P139-HD

DIGITAL AUDIO SYSTEM

BELL 204 / 212/ 412 INSTALLATION

MDL GA212 Rev A STC SR02270SE

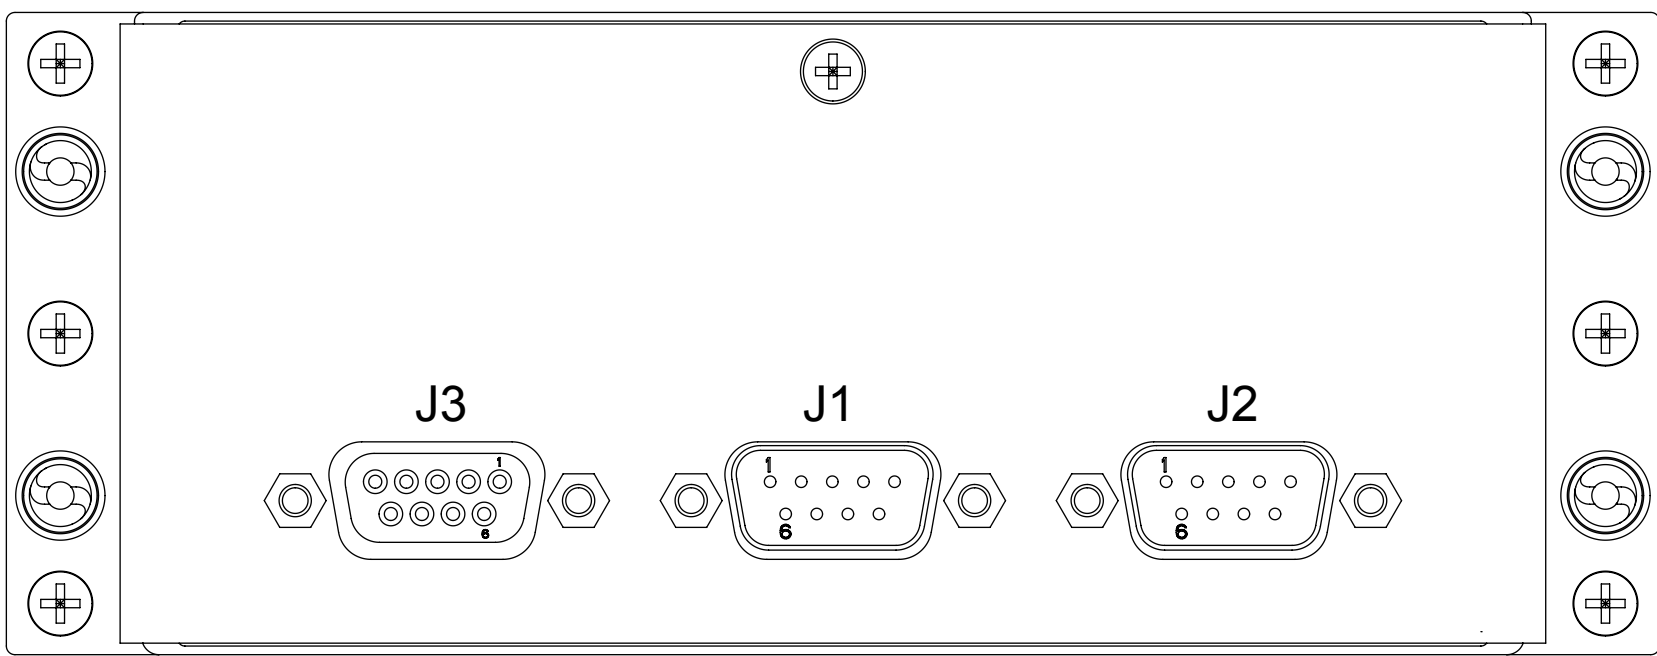
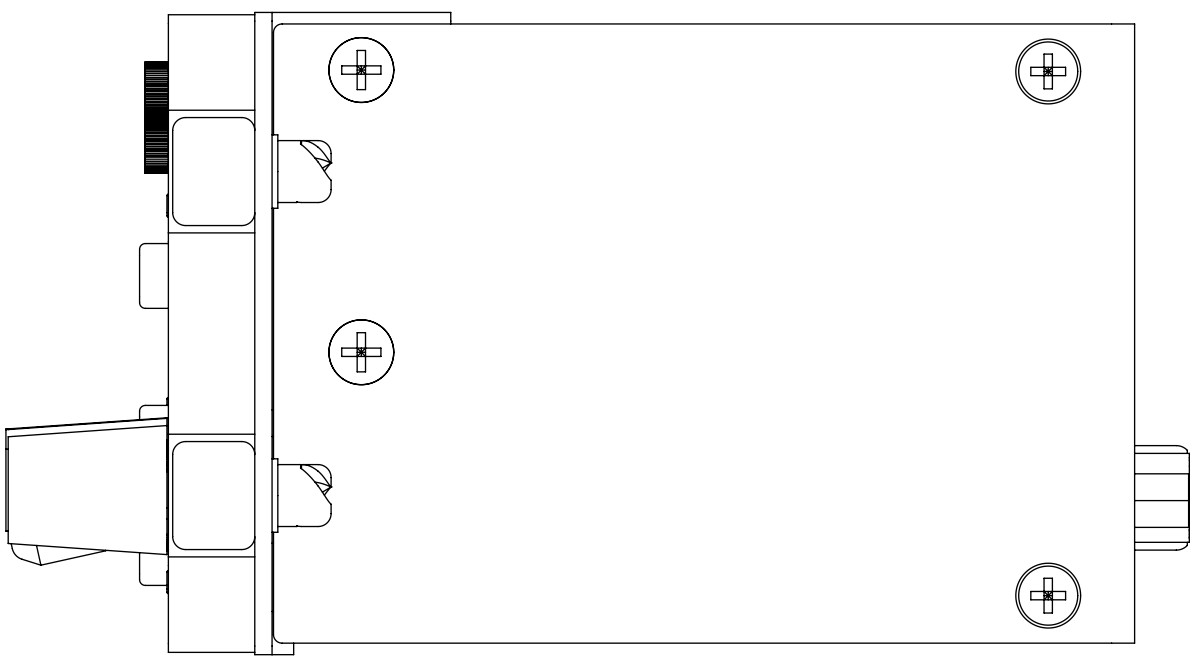
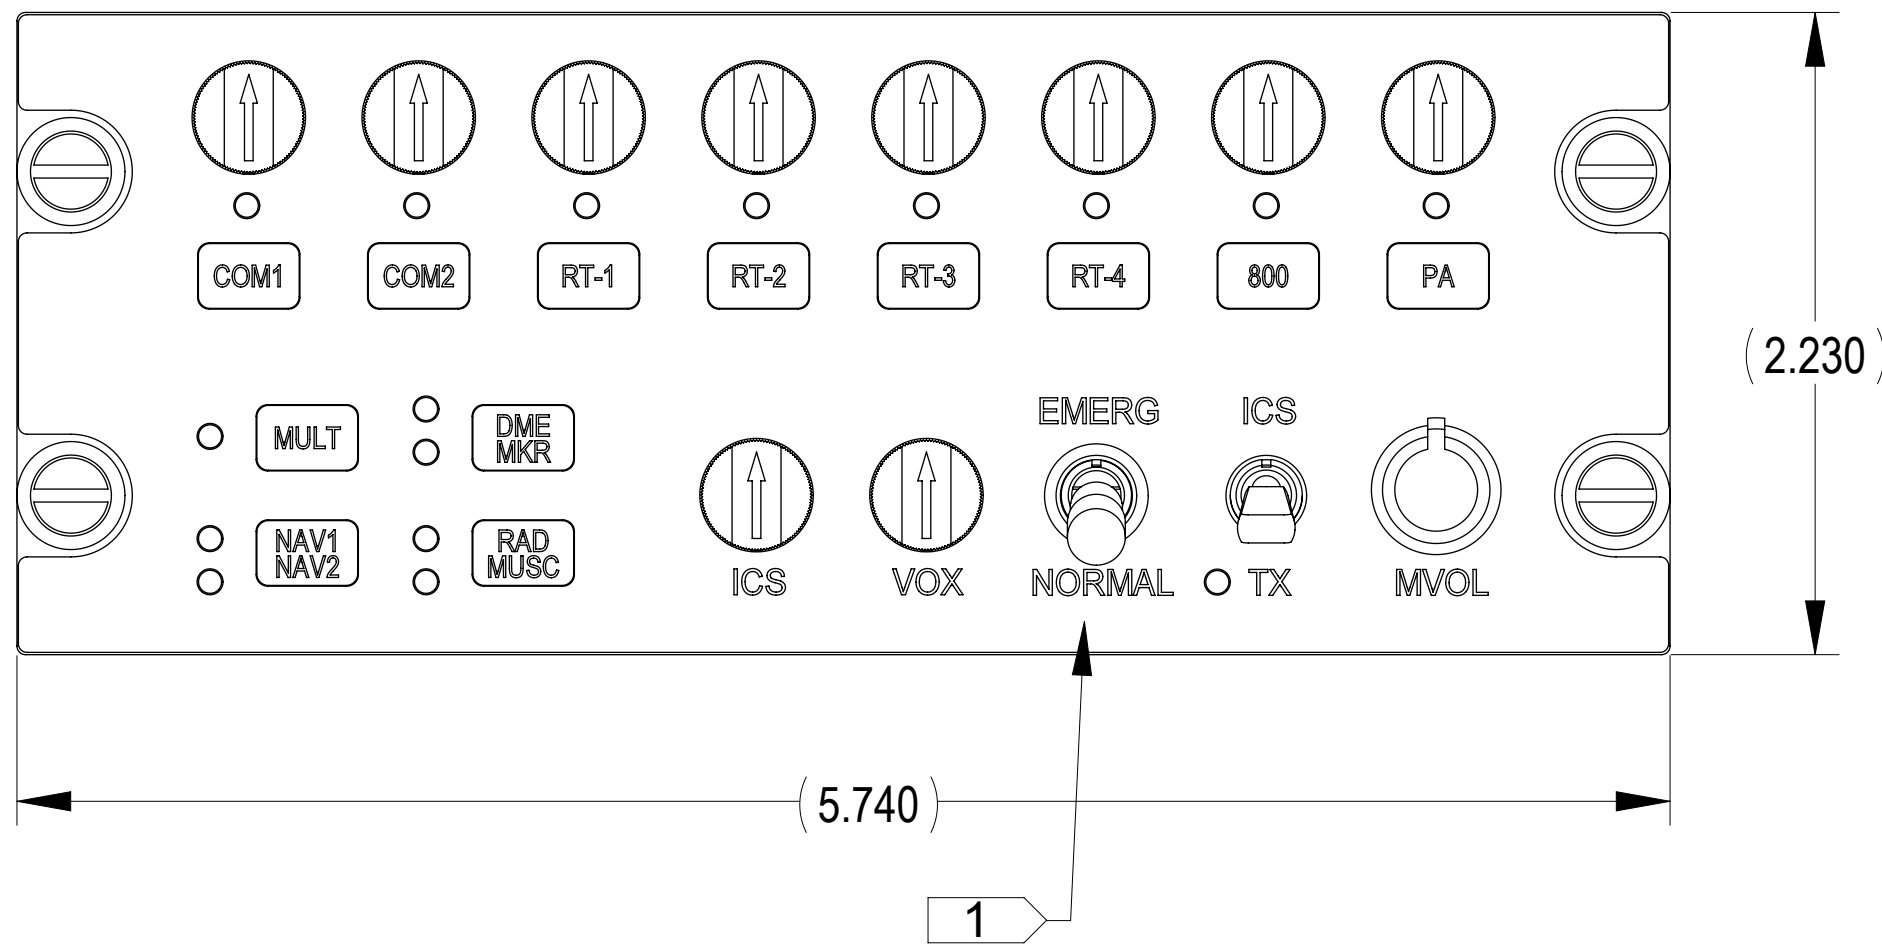
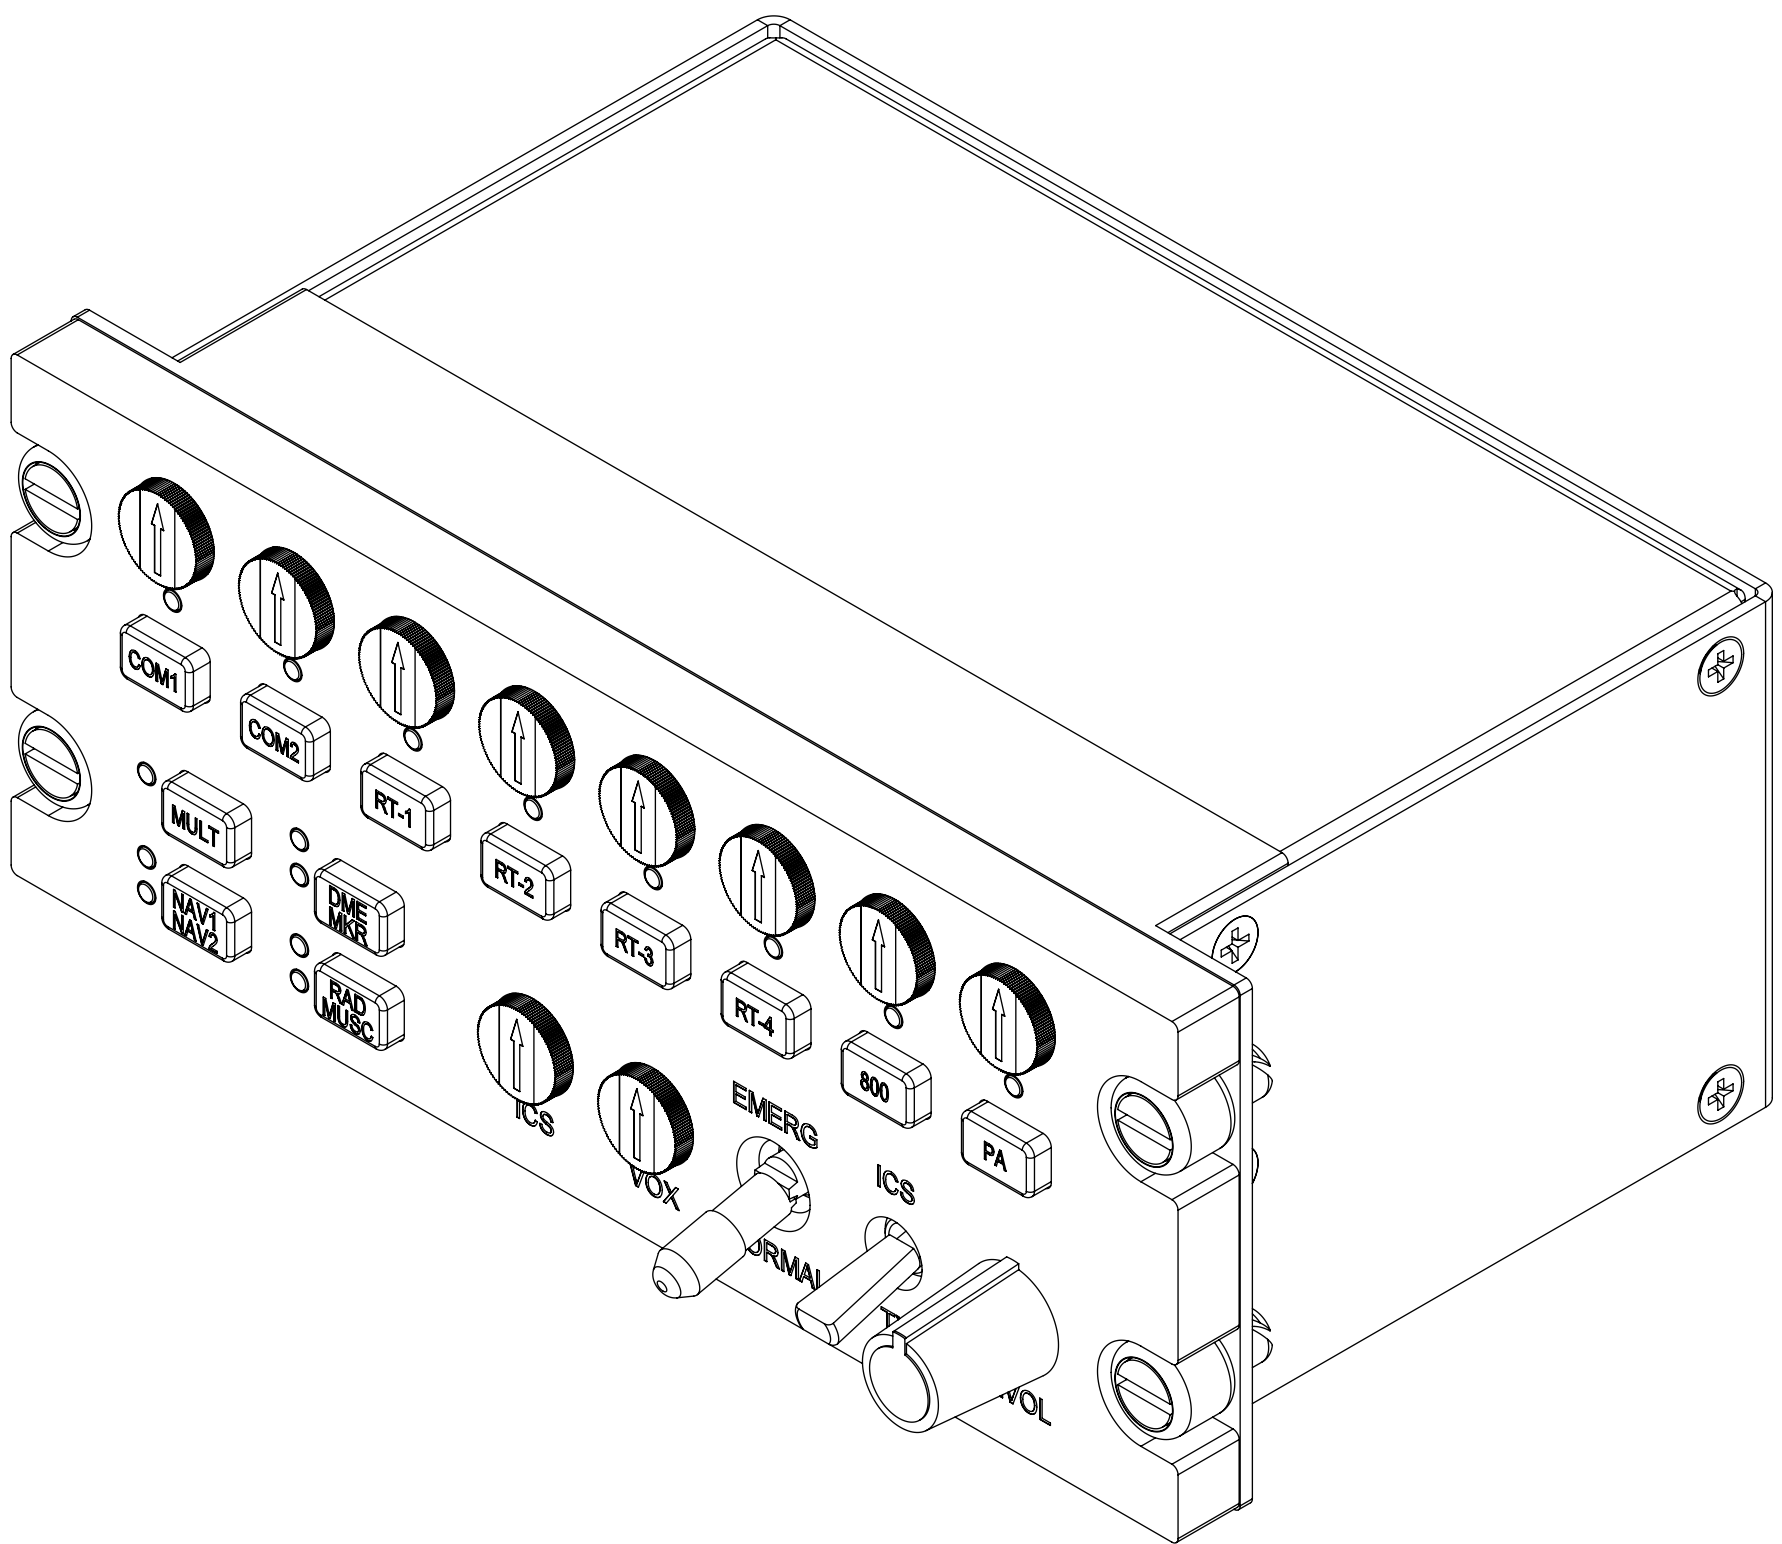
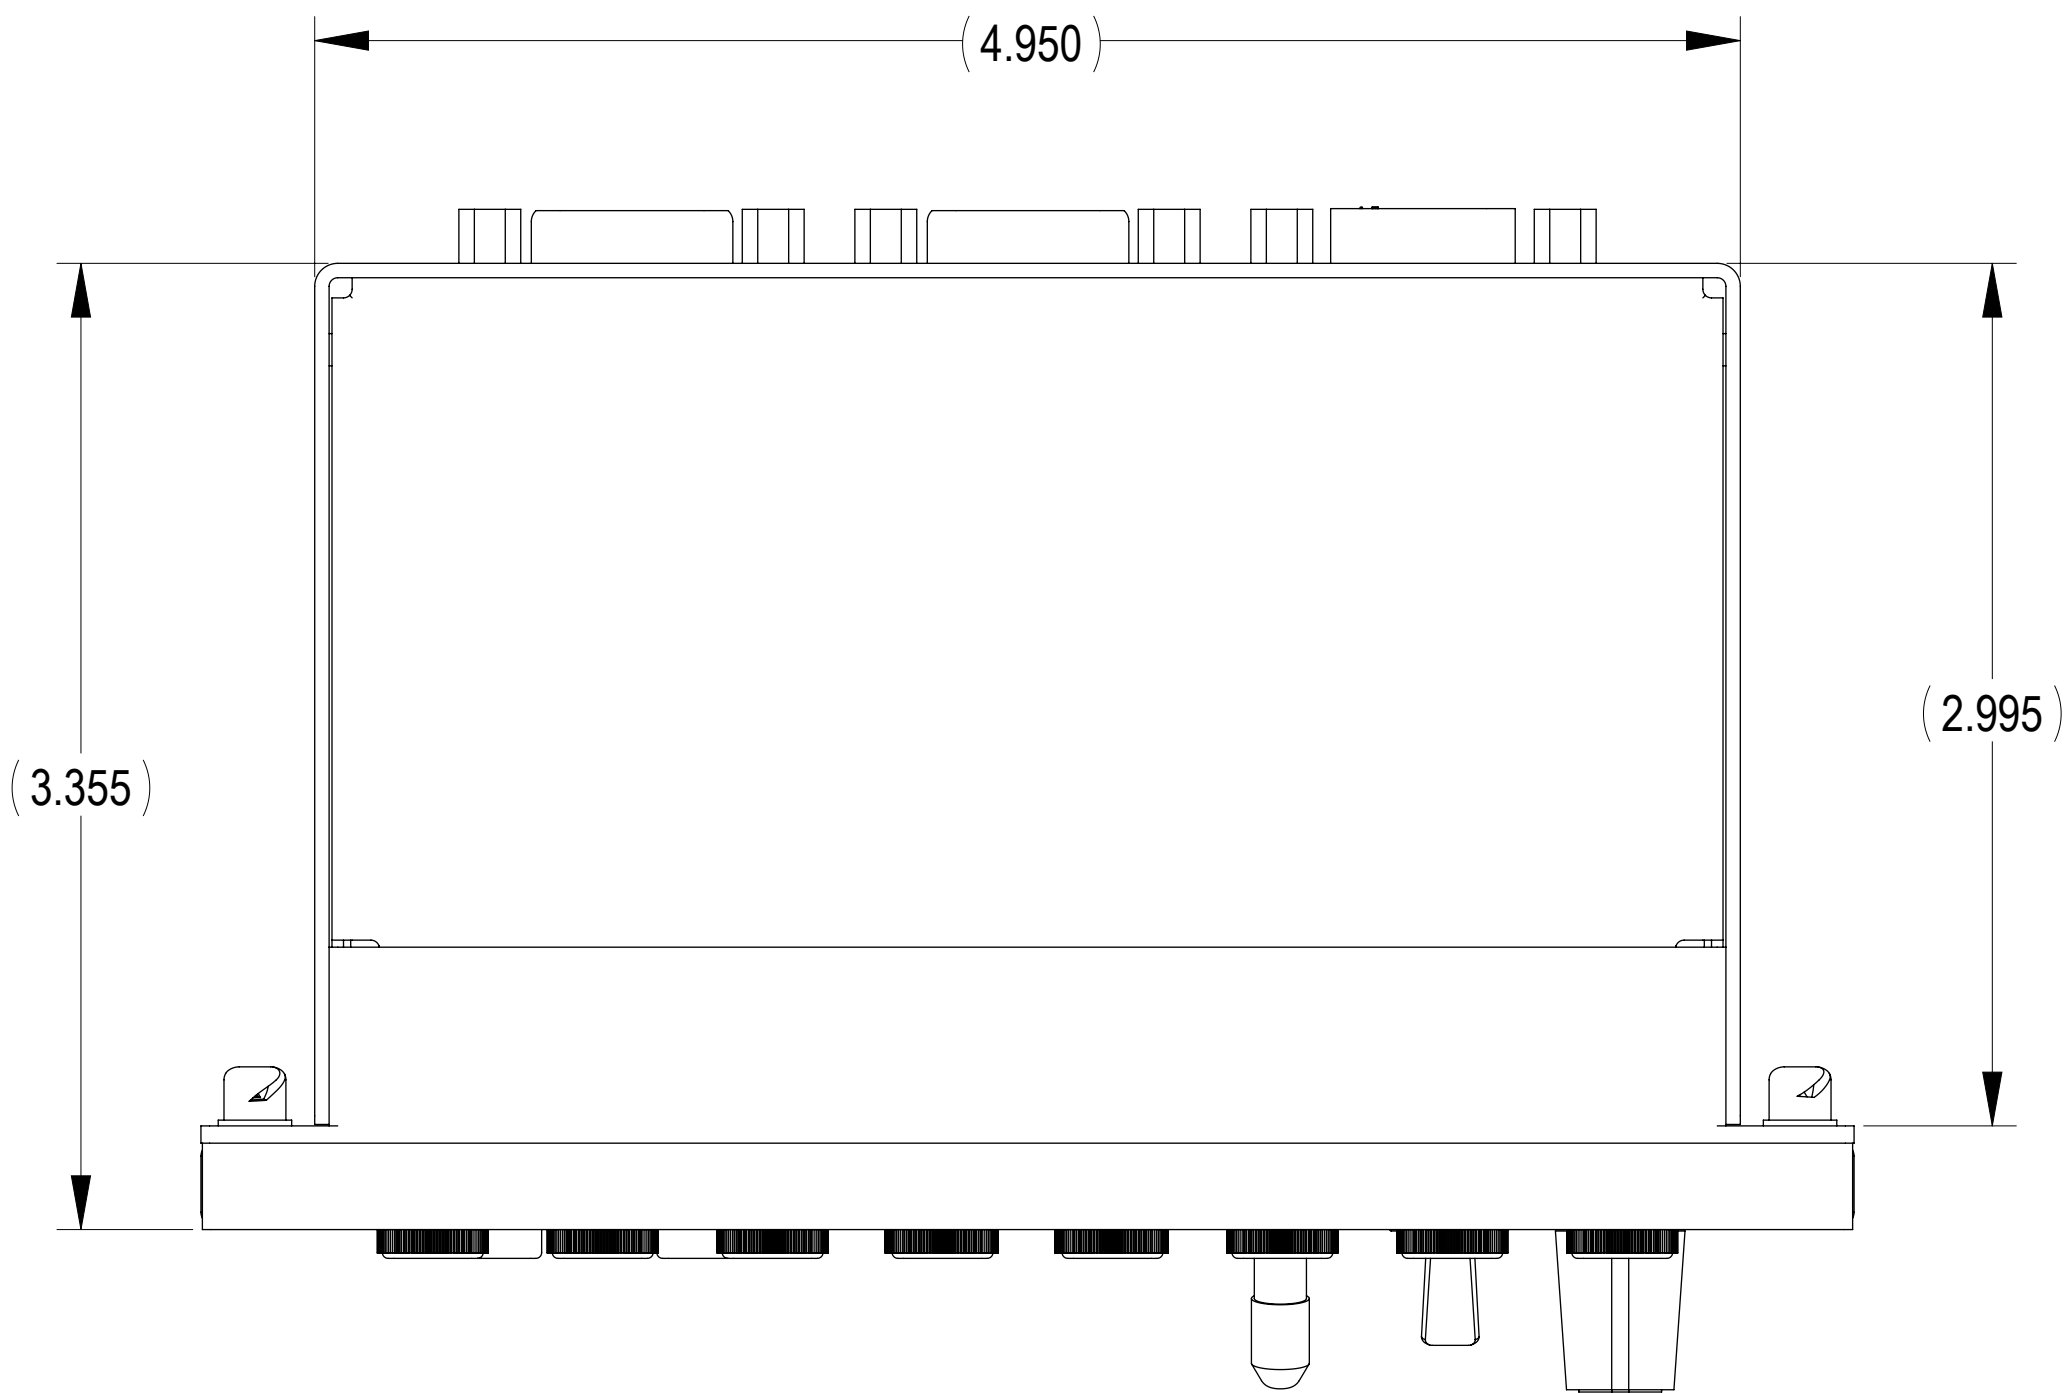
G13116: Revised labeling notes to engineering standards.

REVISIONS		
REV	DESCRIPTION	APPROVED/DATE
A	ADDED P/N G13116NS	10/15/12 CLB
B	REVISED NOTES	3/26/14 CLB
